KENNY DO SUBDIVISION

Engineering Comments: FINAL PLAT COMMENTS (should be addressed prior to submitting the FINAL PLAT for acceptance and signature by the City Engineer):

APPLICATION NUMBER 4 DATE November 7, 2019

DETAIL SITE PLAN

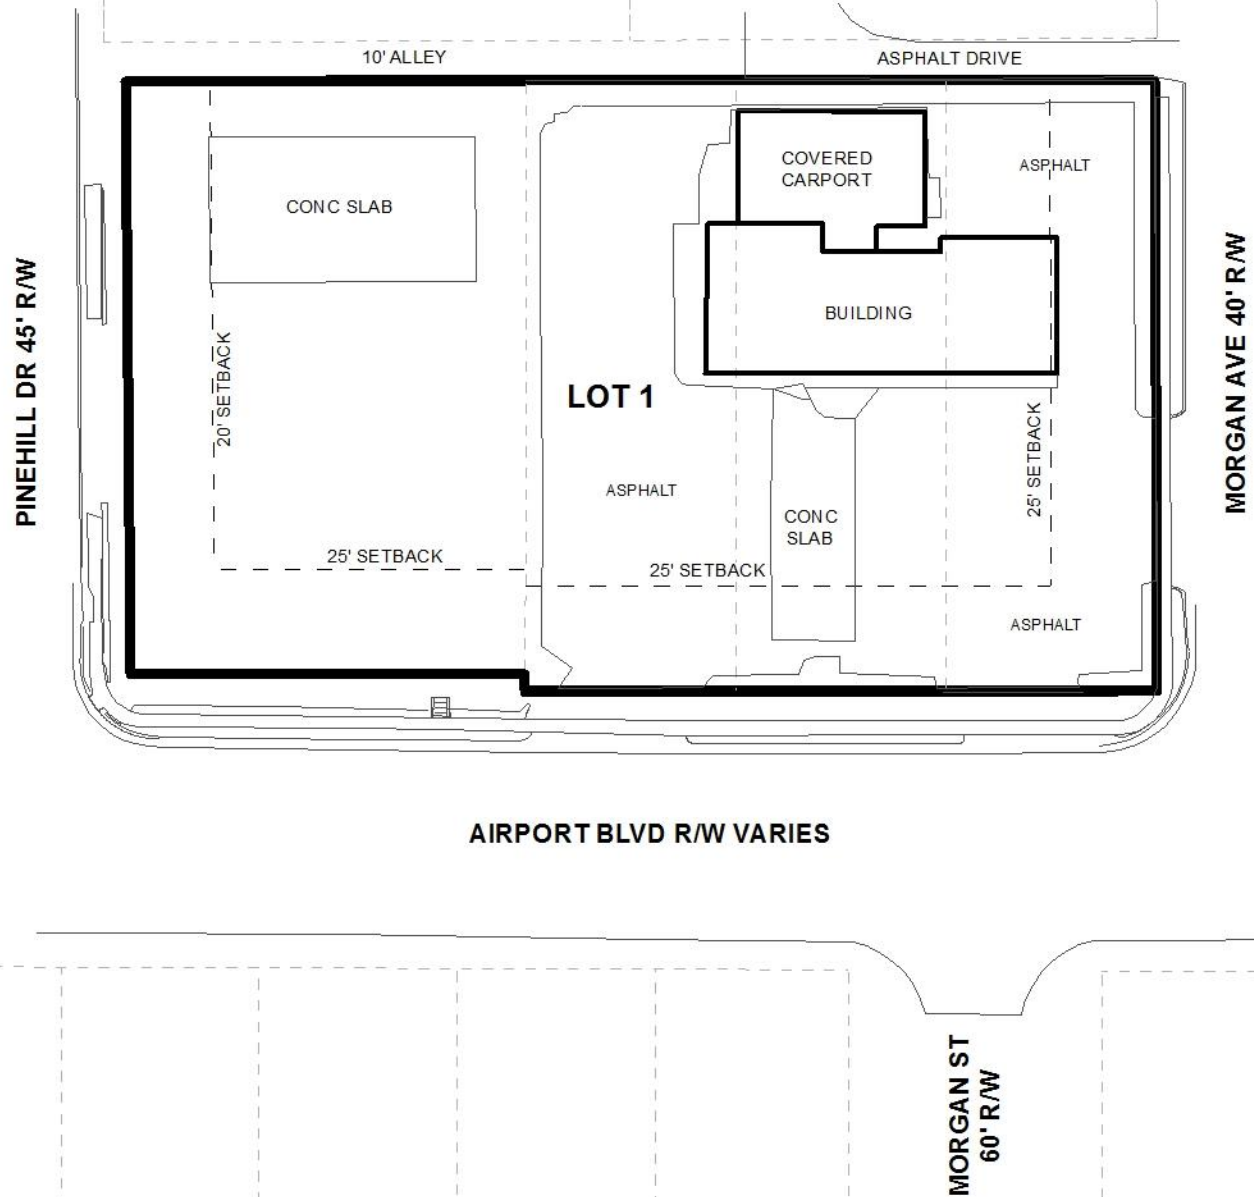
- B. Add street names to the vicinity map.
- C. Dedicate the corner radius (15') at the southwest and the southeast corner of LOT 1 to the City of Mobile, and list the amount of dedicated acreage.

The Proposed Plat illustrates right-of-way widths of 40 feet along Morgan Avenue, 45 feet along Pinehill Drive, and states that the right-of-way varies along Airport Boulevard. Morgan Avenue and Pinehill Drive are both minor streets with curb and gutter and have a right-of-way width requirement of 50 feet per the Subdivision Regulations. Airport Boulevard is a major street, and as such, requires an 80 foot right-of-way per the Major Street Plan. At the December 18, 2008 meeting of the Planning Commission, a subdivision was approved for 2356 Airport Boulevard conditioned upon the applicant revising the Final Plat to depict existing rights-of-way widths for Airport Boulevard (the West half of the subject property) and Pinehill Drive as well as dedication sufficient to provide 25 feet from the centerline of Pinehill Drive and 40 feet from the centerline of Airport Boulevard.

As the rights-of-way illustrated on the proposed plat are deficient, if approved, the Final Plat should be amended to depict existing rights-of-way widths for Morgan Avenue, Pinehill Drive and Airport Boulevard as well as dedication sufficient to provide 40 feet from the centerline of Airport Boulevard and 25 feet from the centerline of both Morgan Avenue and Pinehill Drive as necessary. Dedication of a corner radius in compliance with Section V.D.6. of the Subdivision Regulations at both the Northwest corner of Airport Boulevard and Morgan Avenue, and at the Northeast corner of Airport Boulevard and Pinehill Drive, will be required. In addition, the revision of minimum building setback lines adjusted for dedication will be required.

The lot size labels in both square feet and acres should be retained on the Final Plat or a table should be furnished on the Final Plat providing the same information. As a means of access management, a note containing the Traffic Engineering comments should be placed on the Final Plat.

- 1) retention of the lot size labels in both square feet and acres on the Final Plat or the furnishing of a table on the Final Plat providing the same information, adjusted for dedication;

- 2) provision of dedication sufficient to provide 25 feet as measured from the centerline of both Morgan Avenue and Pinehill Drive, as appropriate;
- 3) provision of dedication sufficient to provide 40 feet as measured from the centerline of Airport Boulevard, as appropriate;

- 4) provision of a corner radius in compliance with Section V.D.6. of the Subdivision Regulations at the Northwest corner of Airport Boulevard and Morgan Avenue and at the Northeast corner of Airport Boulevard and Pinehill Drive;

- 5) revision of the minimum building setback, adjusted for dedication;
- 6) compliance with the Engineering comments: *FINAL PLAT COMMENTS (should be addressed prior to submitting the FINAL PLAT for acceptance and signature by the City Engineer): A. Provide all of the required information on the SUBDIVISION PLAT (i.e. signature blocks, signatures, certification statements, written legal description, required notes, legend, scale, bearings and distances) that is required by the current Alabama State Board of Licensure for Professional Engineers and Land Surveyors. B. Add street names to the vicinity map. C. Dedicate the corner radius (15') at the southwest and the southeast corner of LOT 1 to the City of Mobile, and list the amount of dedicated acreage. D. Provide the Surveyor's, Owner's (notarized), Planning Commission, and*
